SERVICE INSTRUCTIONS

No. 0731-114
ATA Code 52-10

SUBJECT: DOORS - REPLACEMENT OF DOOR HANDLES AND CABIN DOOR LATCH BOLTS

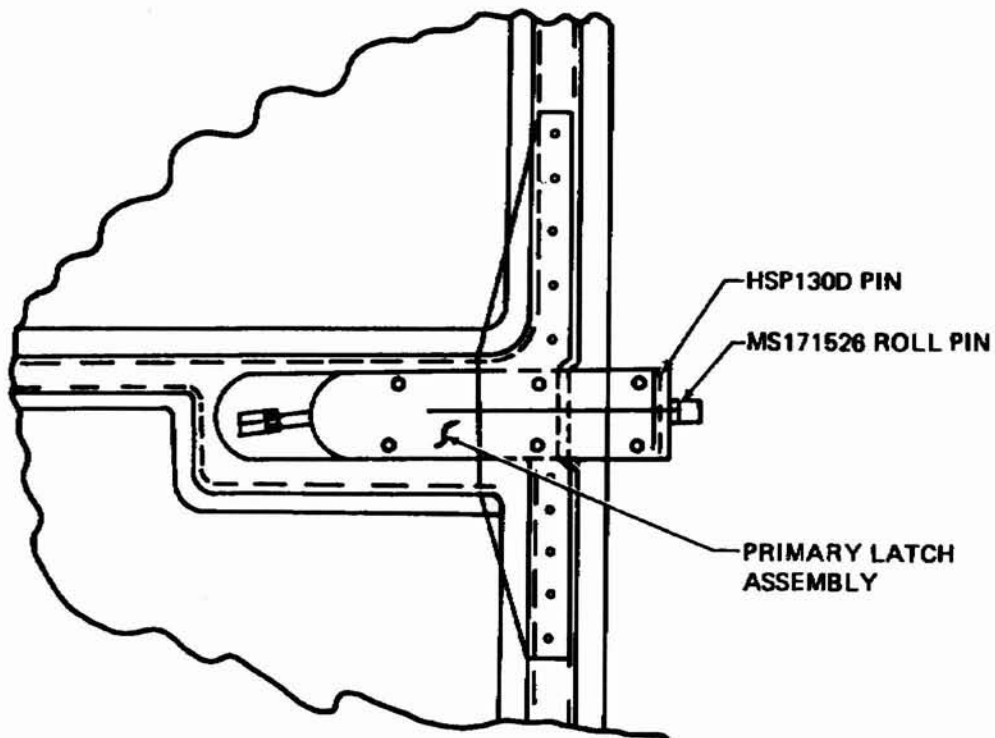
- PART I ONLY 3. Remove the eight attaching screws and slide the primary latch assembly aft as shown in illustration. Remove the swelled HSP130D pin by driving with small punch through housing of latch.

- PART I ONLY 4. Pull shaft and latch bolt aft to gain access to rivet pin. Split old plastic latch bolt and remove the rivet pin. Install new P/N 111501-1 steel latch bolt over shaft and install P/N MS171526 roll pin through latch bolt and shaft.

- PART I ONLY 5. Slide shaft and latch bolt back in housing and install new P/N HSP130D pin with head of pin on top side. Swage lower end of pin by using a center punch. Slide latch assembly back in door to original position and install the eight attaching screws.
